Delegated Report		Analysis sheet		Expiry Date:	07/07/20	
		N/A / attached		Consultation Expiry Date:	12/07/2020	
Officer			Application N	umber(s)		
Jaspreet Chana			2020/2072/P			
Application	Address		<b>Drawing Num</b>	bers		
23-27 King's Terrace London NW1 0JP			See draft decis	sion		
PO 3/4	Area Team Signature	e C&UD	Authorised Of	fficer Signature		
Proposal

Erection of a mansard roof extension to provide two 1 bedroom flats

Recommendation:	Refuse permission						
Application Type:	Full planning permission						
Consultations	Consultations						
Summary of consultation:	Three site notices were displayed on the 17/06/2020 (consultation end date 11/07/2020).  The development was also advertised in the local press on the 18/06/2020 (consultation end date 12/07/2020).						
Adjoining Occupiers:		No. of responses	00	No. of objections	00		
Summary of adjoining occupiers' consultation responses:	N/A

(Figure 1: Officers own section for assessment)

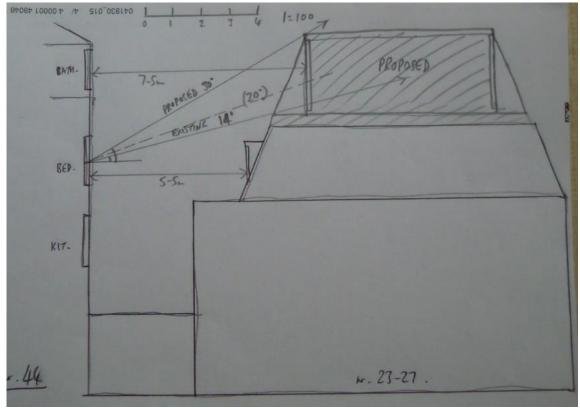
- 5.5. However on property 44 second floor there is a bedroom which is obscure glazed although outlook or privacy will not be impacted daylight the daylight received to this window may be impacted. Officers have devised our own section drawing (below) which shows that the daylight could be affected to the bedroom.

- 5.6.BRE guidelines say that an unobstructed angle of 20 degrees or less to the centre of window means there should be sufficient day and sunlight to the room. If not, then a more detailed assessment is needed to test VSC results. Currently there is a 14 degree angle from the existing mansard whereas the new extension will result in a 30 degree angle. Without a proper daylight study using VSC criteria by professional consultants, this could be potentially harmful to the occupiers of the occupiers of No.44.
